Service Information

Category J	Repair Guidance	Ref. No. R083/16 B	Page 1 of 3
Coverage <input type="checkbox"/> Distributor only <input checked="" type="checkbox"/> Please inform your dealers		Date Issued October 10, 2016	
Please convey this information to your <input type="checkbox"/> Director <input checked="" type="checkbox"/> General Manager <input checked="" type="checkbox"/> Warranty Dept. <input checked="" type="checkbox"/> Parts Dept. <input checked="" type="checkbox"/> Training Dept. <input checked="" type="checkbox"/> Field Rep.		Date Revised March 8, 2017	
Applicable Model MX-5 (ND) with Manual Transmission		Applicable Countries and/or Vehicle Specifications Worldwide

Subject: Unusual Noise from Manual Transmission when driving in 2nd and/or 3rd Gear

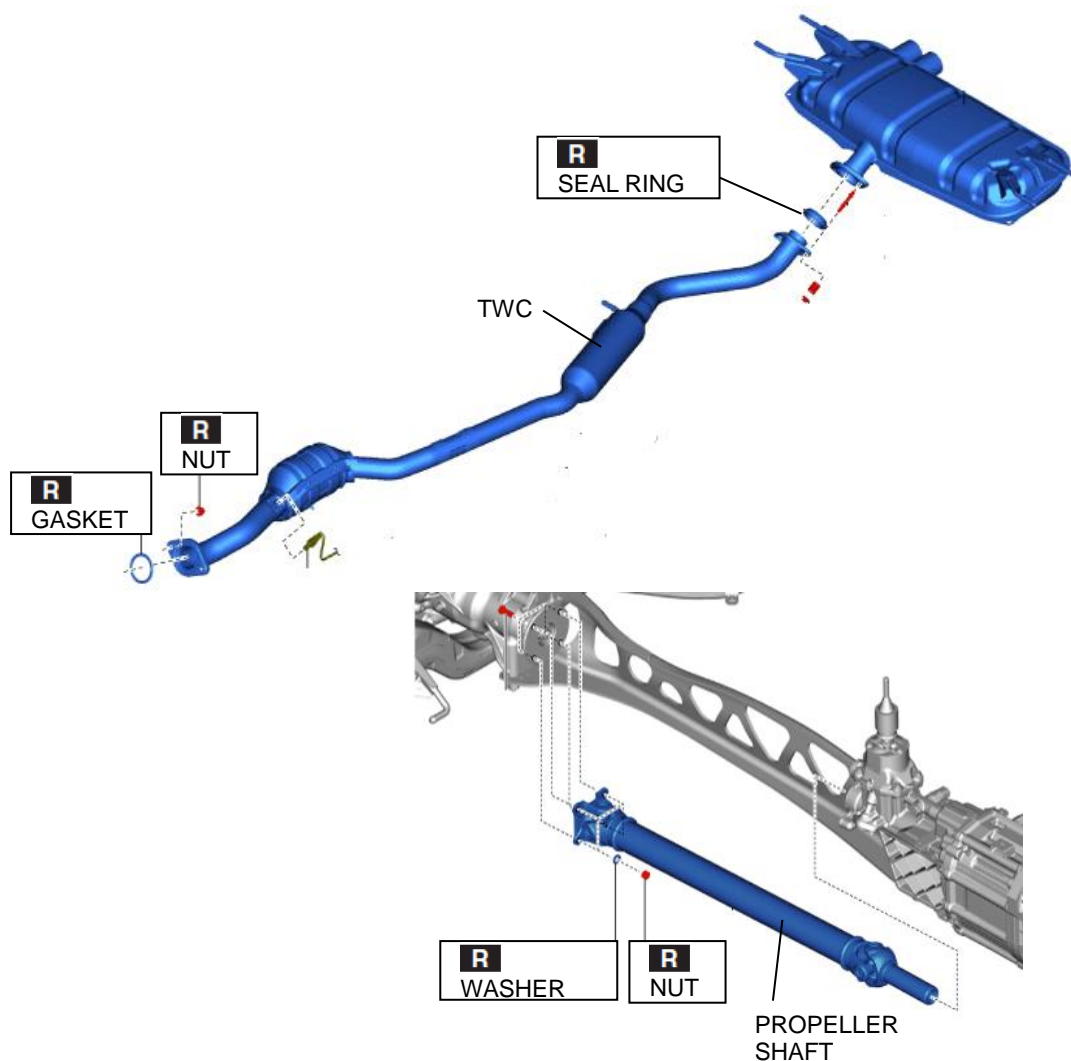
The configuration of the 2nd and 3rd gears has been changed to increase the rigidity.

NOTE: Transmissions with the serial No. "6TJ0900496" or higher are modified.
